Greenwood Gold Project

Tailings Storage Facility - Dam Safety Review

November 25, 2014

Greenwood Gold Project
Tailings Storage Facility - Dam Safety Review

Figure 3.1 Typical Starter Dam Embankment Cross Section (Sta. 3+50)

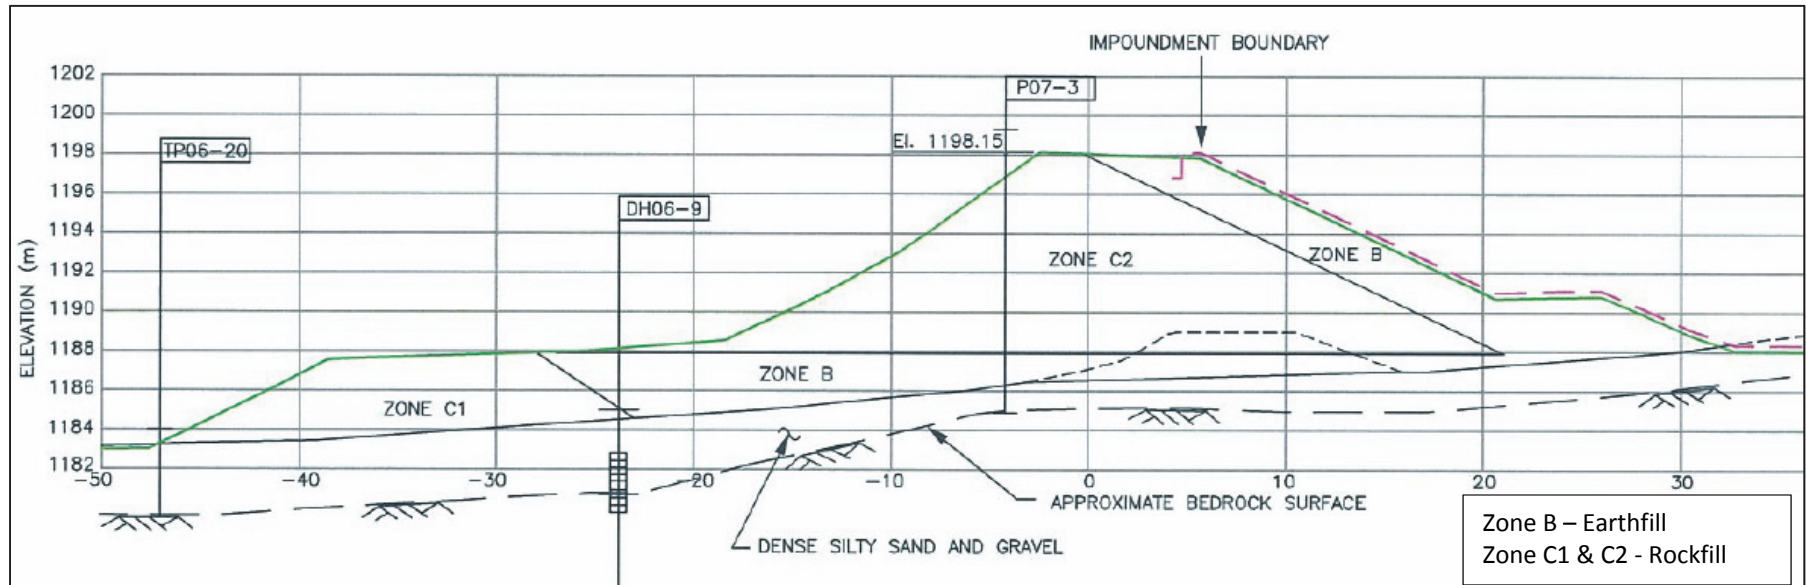
The most recent stability analysis for the Starter Dam was completed in 2007, prior to modification of the embankment cross section during construction. The modifications include:

These modifications all increase the factor of safety; therefore, an update to the stability analysis is not required.

Figure 5.1 Maximum Inundation Area for Rainy Day Dam Breach- 1.7 km from base of TSF to Highway 3 (12% grade) and 2.2 km to nearest permanent dwelling (average 10% grade) (Google Earth 2014)

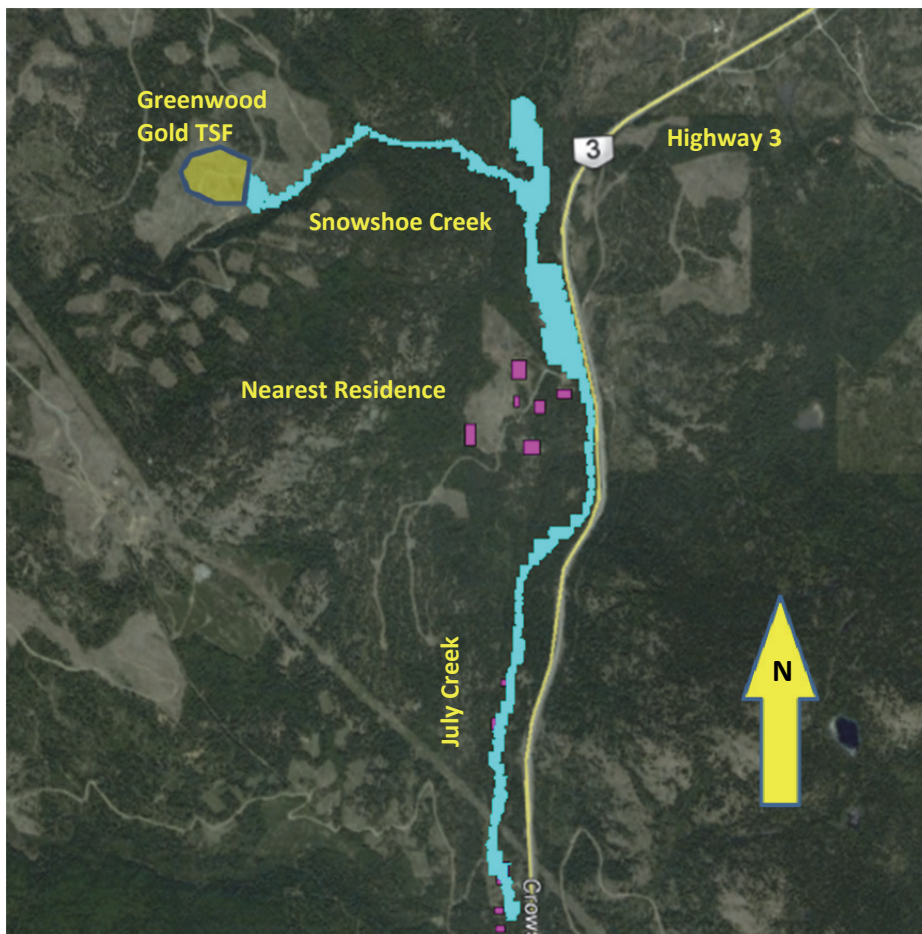
Figure 5.1 shows the expected inundation flow path, which follows Snowshoe Creek and into July Creek, where it parallels Highway 3 and passes by several residences.

The revised classification of the TSF, using CDA 2013 and the inundation study was reviewed with respect to the revised 2007 categories as follows, based on review of available information:

PROJECT	GREENWOOD GOLD TAILINGS STORAGE FACILITY		
TITLE	SITE A DAM PLAN		
SCALE	PROJECT No.	DWG. No.	REV.
AS SHOWN	M09200 A07	D-7006	1

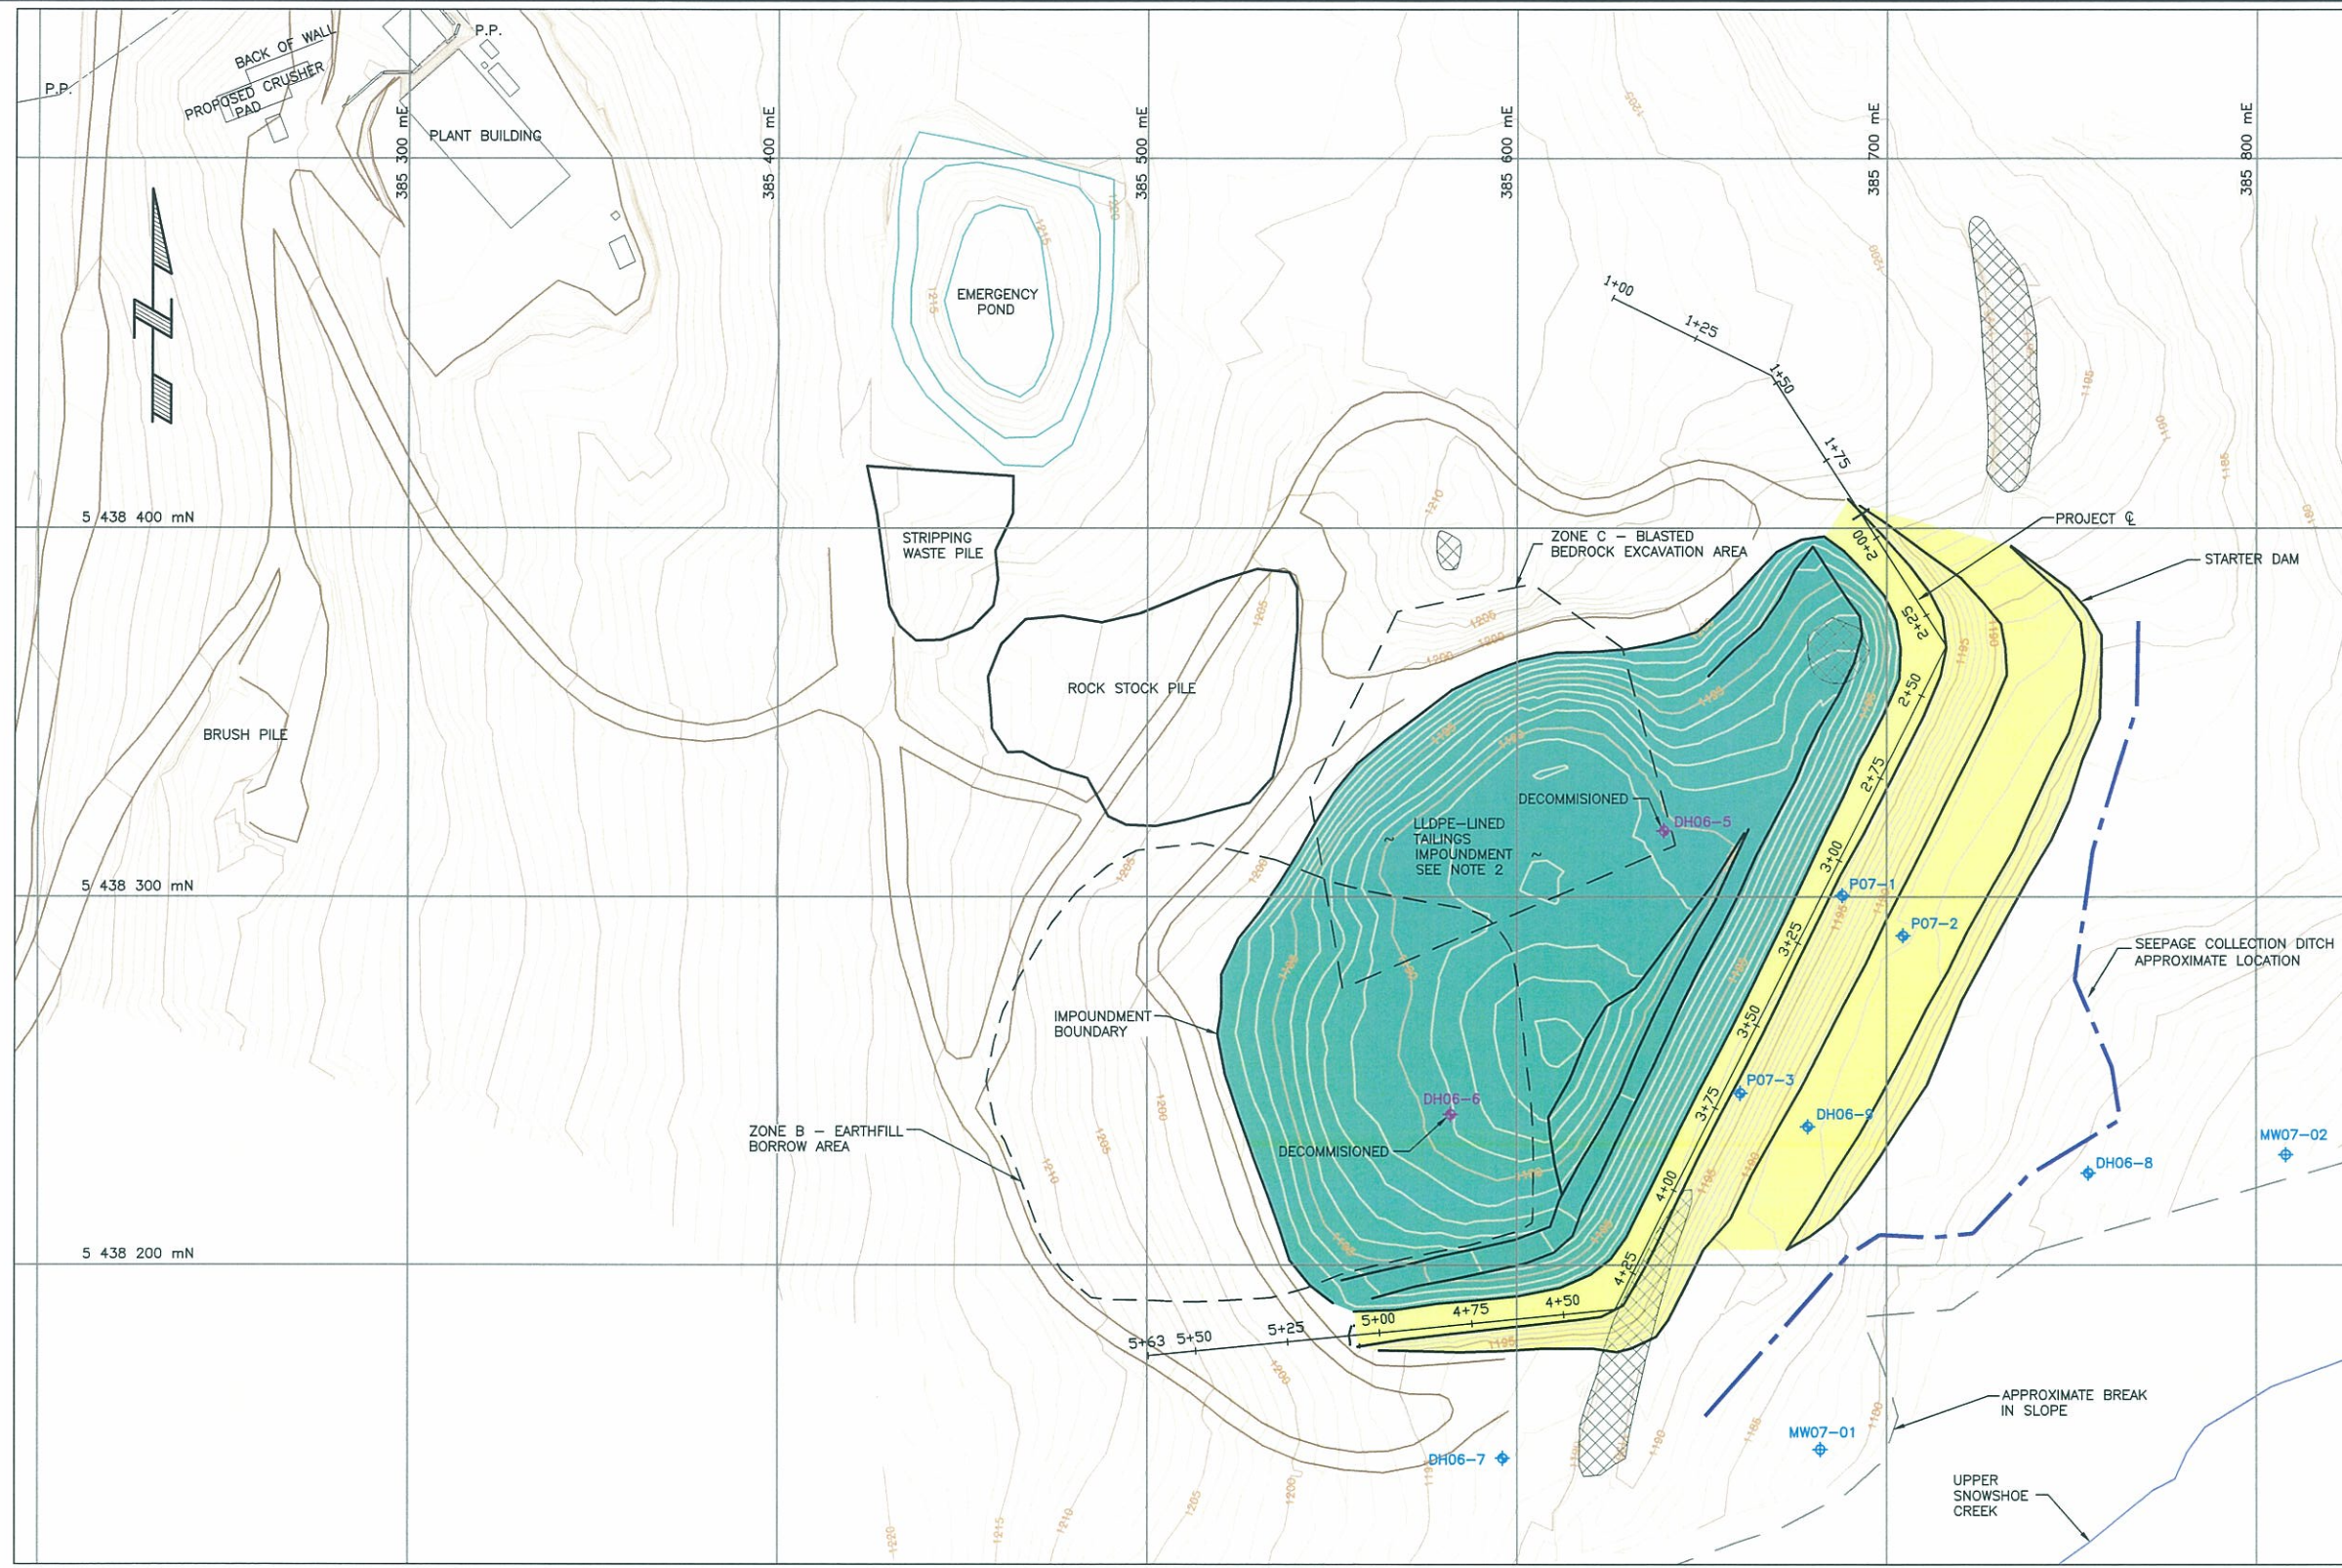
The EWP dam is approximately 2.5 m high and appears to be capable of storing in the order of 10,000 m³ of water at crest level (according to drawing D-7006 Rev.1). As such the EWP does not meet the definition of a “dam” under CDA Dam Safety Guidelines and is not regulated under BC Dam Safety Regulation (Section 2) as long as the failure consequence classification is “Low”. Since the EWP is within the catchment of the TSF, and contains fresh water according to discussions with the Mine Manager, a “Low” classification is appropriate.

Piezometers were installed in the 2006 site investigations for detailed design and additional piezometers and monitoring wells were installed during construction in 2007. Piezometer and observation well locations are shown in Drawing D-7006 from the 2008 “As-Constructed” report by KCB (2008a). Installation details and water level measurements are shown in Table 5.3. The water level measurements in 2008 and 2009 were extracted from the 2009 Dam Safety Inspection Report prepared by Merit Mining Corporation. The water level measurements were assumed to be relative to the top of the standpipe and observation well casings. The water levels in Table 5.3 were corrected to approximate elevations based on estimated top of standpipe elevations. Standpipe elevations should be surveyed the next time a surveyor is on site. No water level measurements were recorded from 2010 to 2013.

PROJECT	GREENWOOD GOLD TAILINGS FACILITY		
TITLE	TEMPORARY SPILLWAY PLAN, PROFILE AND SECTIONS		
SCALE	PROJECT NO.	DWG. NO.	REV.
AS SHOWN	M09951A01	D-1001	0

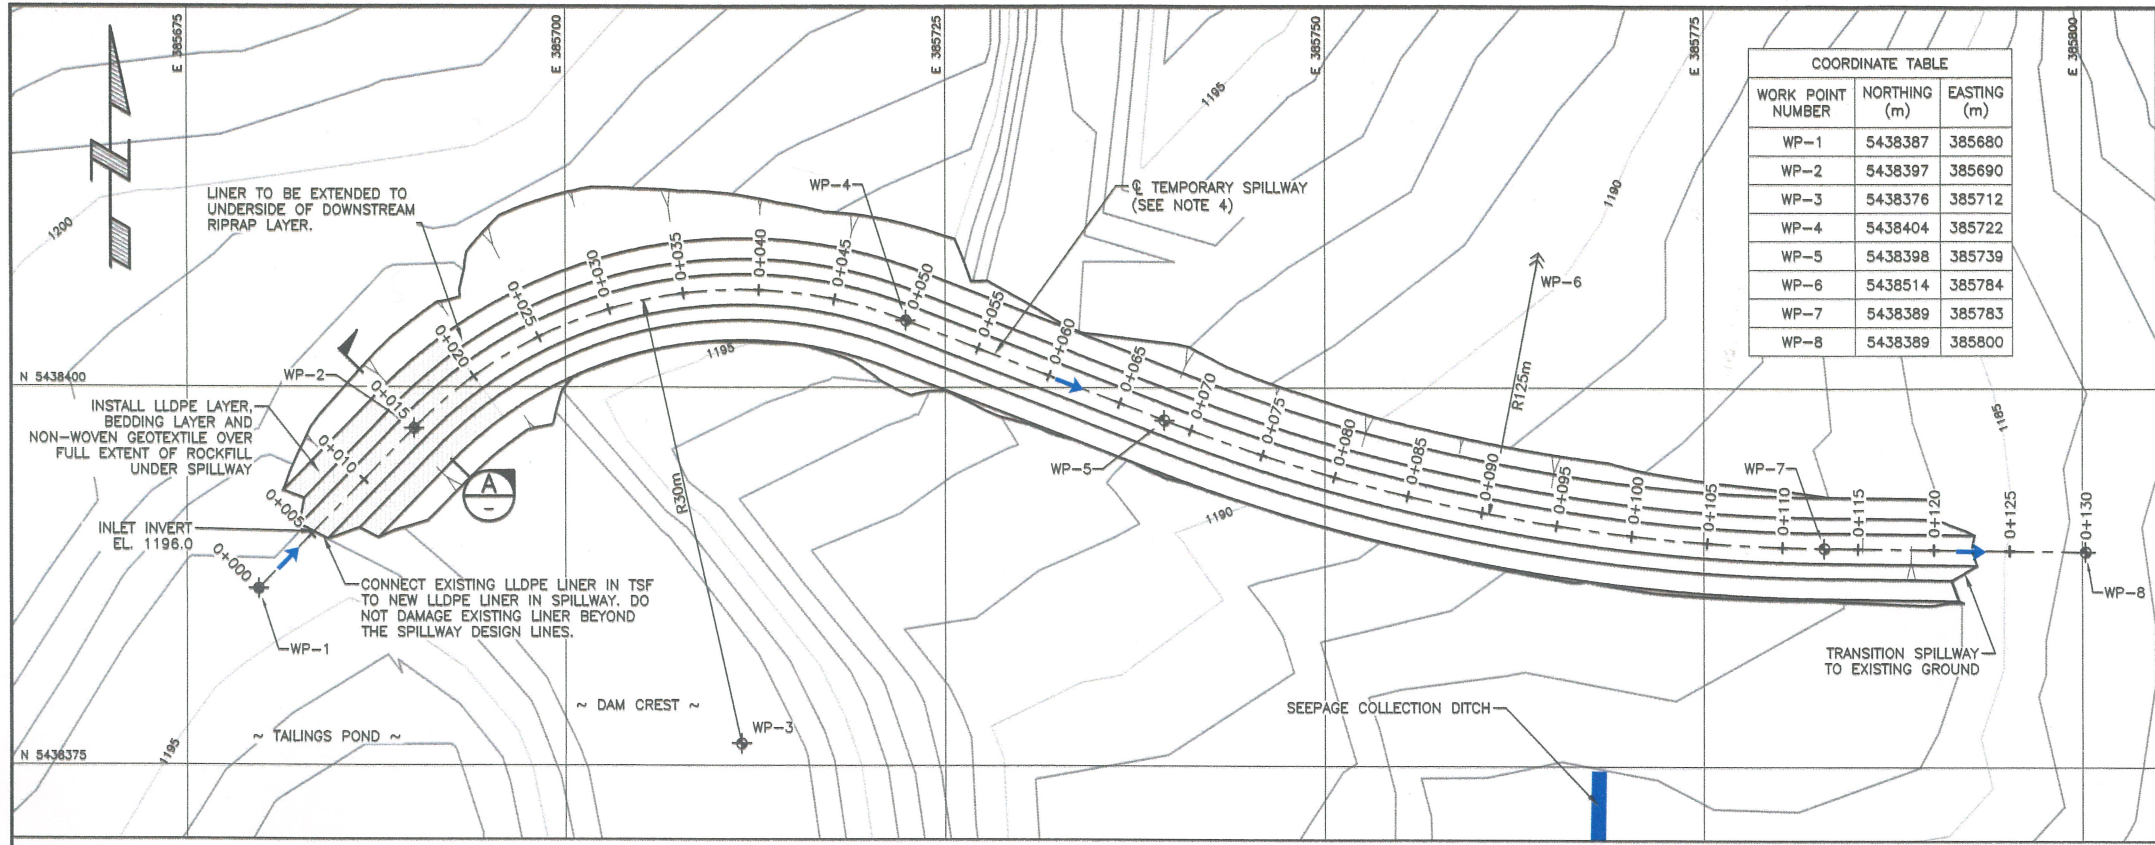
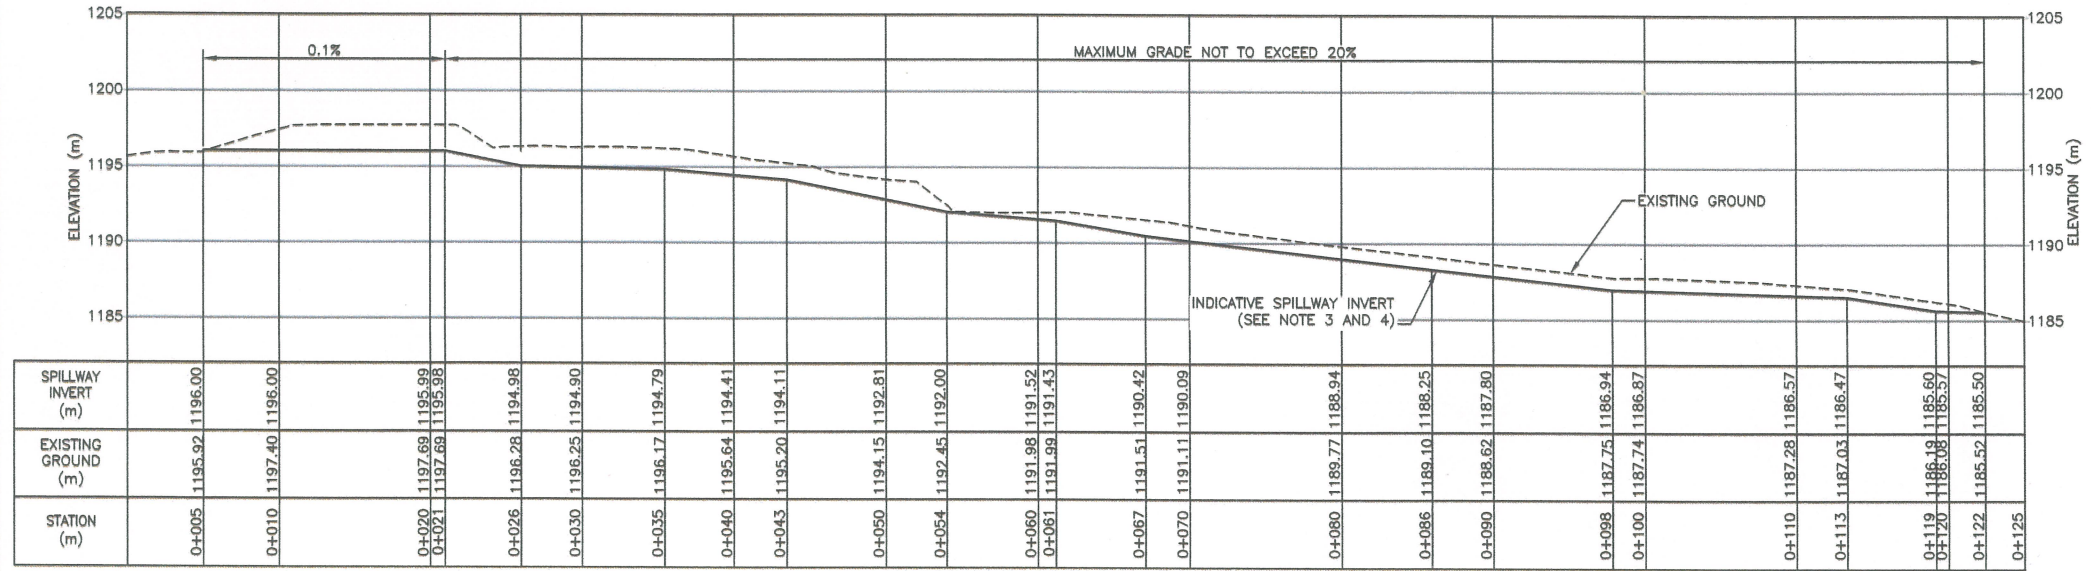
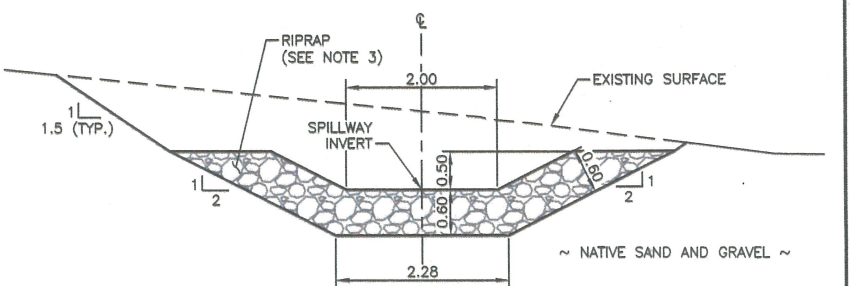
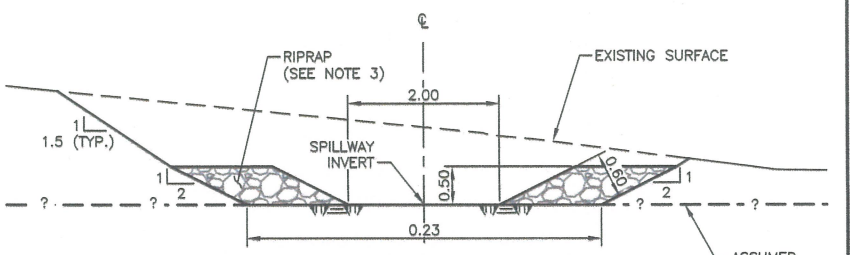
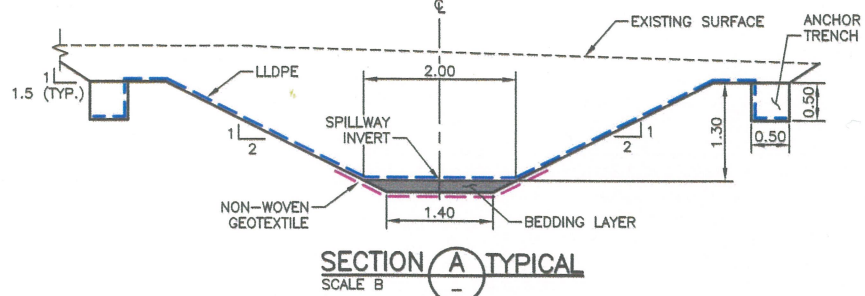
KCB provided design drawings for a left abutment spillway in October 2014 (KCB 2014) after the completion of the DSR inspection. Huakan constructed the spillway in October 2014 and forwarded construction photos as verification of the work (see Appendix VII). The photographs appear to be generally consistent with the design intent although KCB did not monitor the construction of the spillway to verify conformance with the design intent.

A temporary emergency spillway design was commissioned by Huakan following the DSR site visit. This design was completed by KCB (2014), and reportedly constructed by Huakan on October 24, 2014 (e-mail correspondence from Mr. Paul Cowley). Photographs of the spillway construction provided by Huakan are included in Appendix VII, as is a copy of the construction drawing.
